N251NAS1

TECHNICAL BULLETIN

Service Action: Manual Tailgate Water Leaks

MODEL:	MODEL YEAR:	VIN:
Range Rover Velar (LY)	2019	781897-789531

1

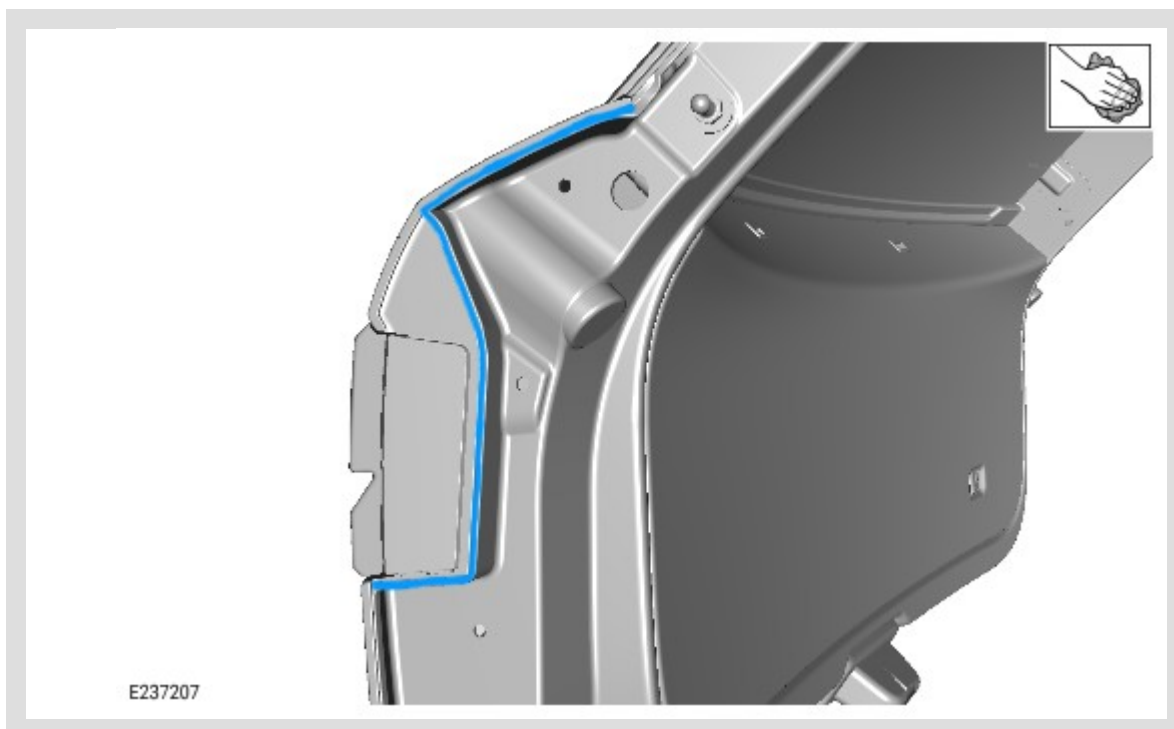
A potential issue has been identified on certain vehicles within the listed Affected Vehicle Range where, in the event of heavy rain or use of jet wash, water may ingress into the tailgate and leak out from the tailgate latch or passenger assist handle.

Clean the area shown.
